IRON WORKERS LOCAL 495

TRAFFIC CIRCULATION LAYOUT

ENGINEER'S MARKUP OF
SURVEYOR'S AS-BUILT

IRON WORKERS LOCAL 495
REVISED GRADING & DRAINAGE PLAN
(NEW HC & DUMPSTER LAYOUT)

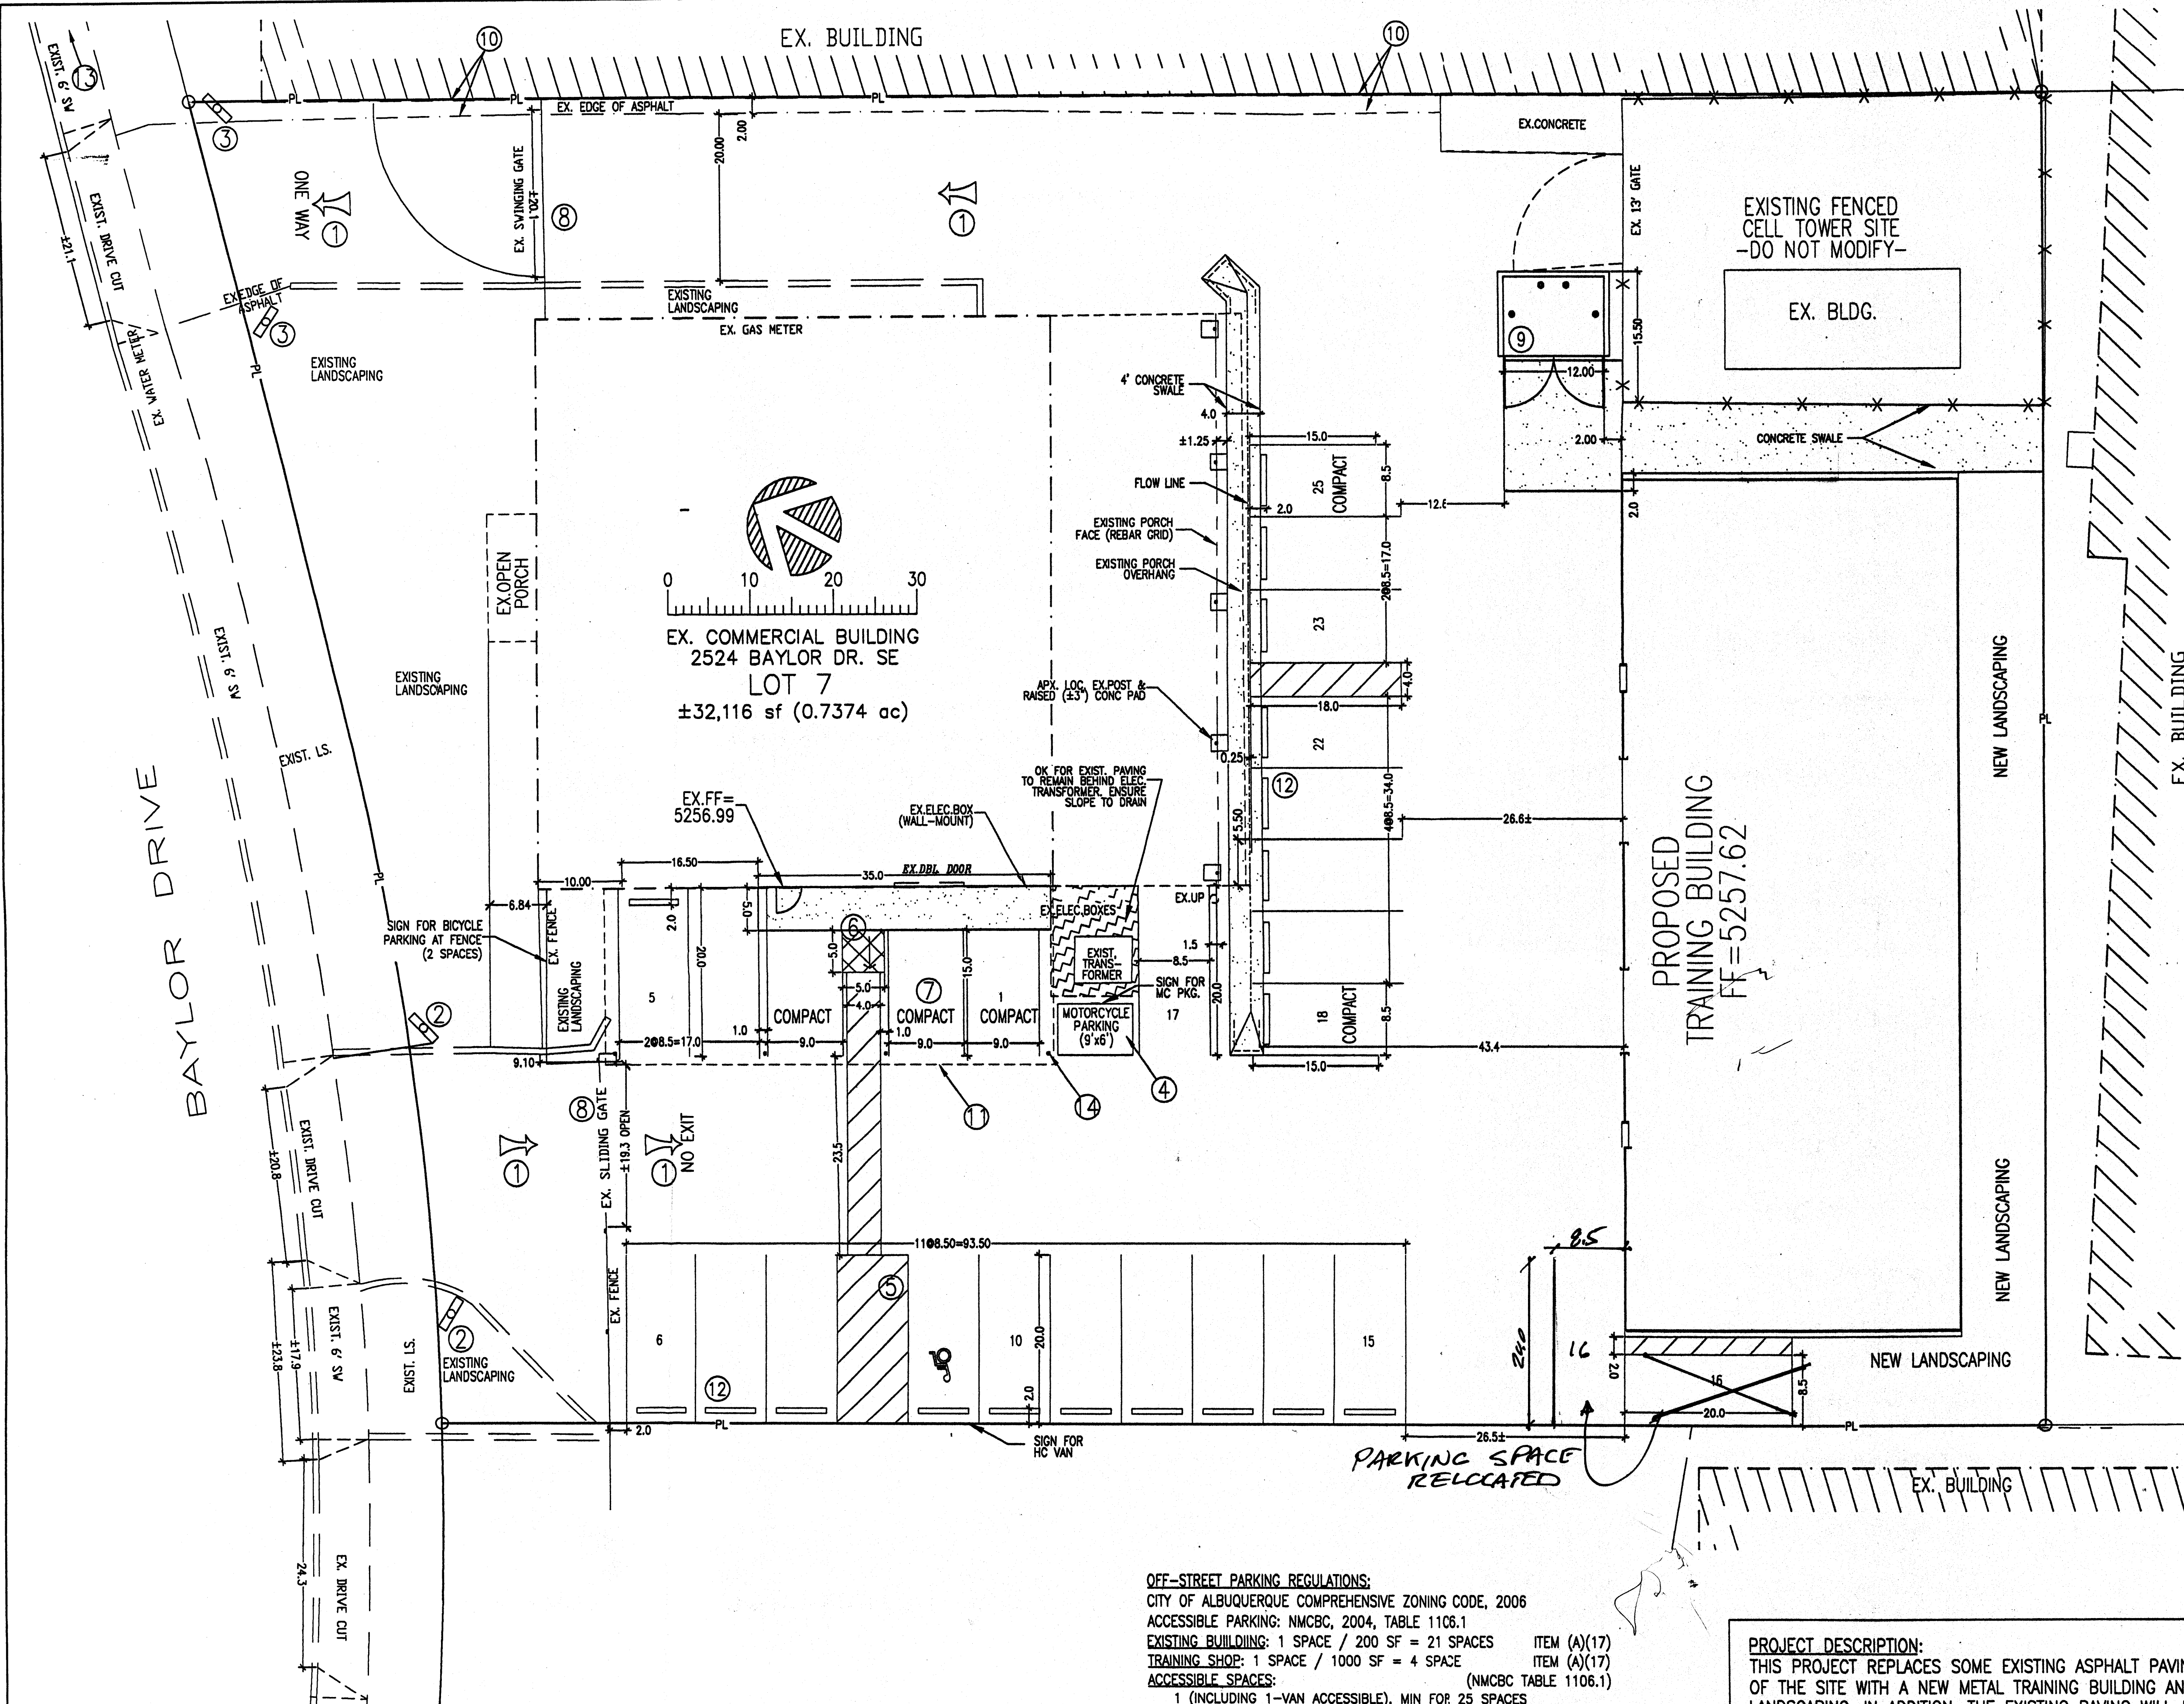
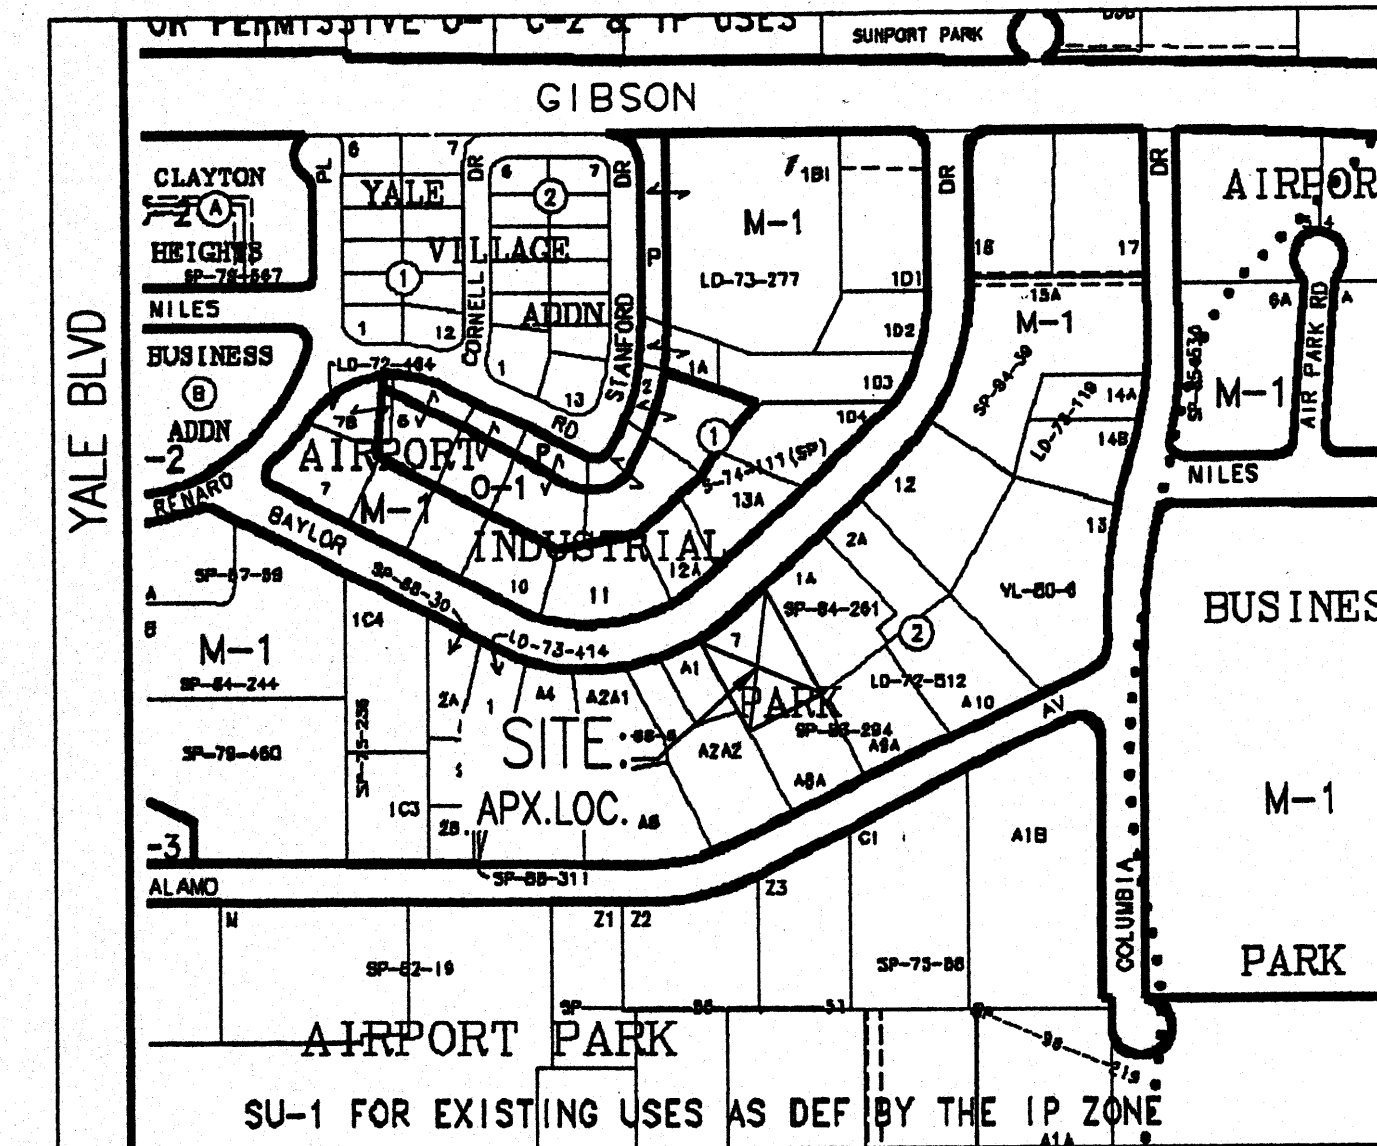
ELEVATION FIELD SHOTS BY PER SE ENGINEERING 10/27/08
BASED ON FINISHED FLOOR AT WEST DOOR OF EXIST. BLDG
= (525)6.99, APX LOCATION OF SHOTS SHOWN.

I HEREBY CERTIFY THAT GRADING AND DRAINAGE FOR THIS PROJECT WAS COMPLETED IN SUBSTANTIAL COMPLIANCE WITH THE APPROVED GRADING AND DRAINAGE PLAN (WITH THE HC PARKING LAYOUT EXCEPTION NOTED SEPARATELY), THAT THE PROJECT APPEARS TO DRAIN SUBSTANTIALLY AS INTENDED, AND THAT THESE CONCLUSIONS ARE BASED ON MY OWN ONSITE OBSERVATIONS AND ON AS-BUILT ELEVATIONS SHOT BY ALBUQUERQUE SURVEYING COMPANY AND BY ME, WITH DAVIS STARR.
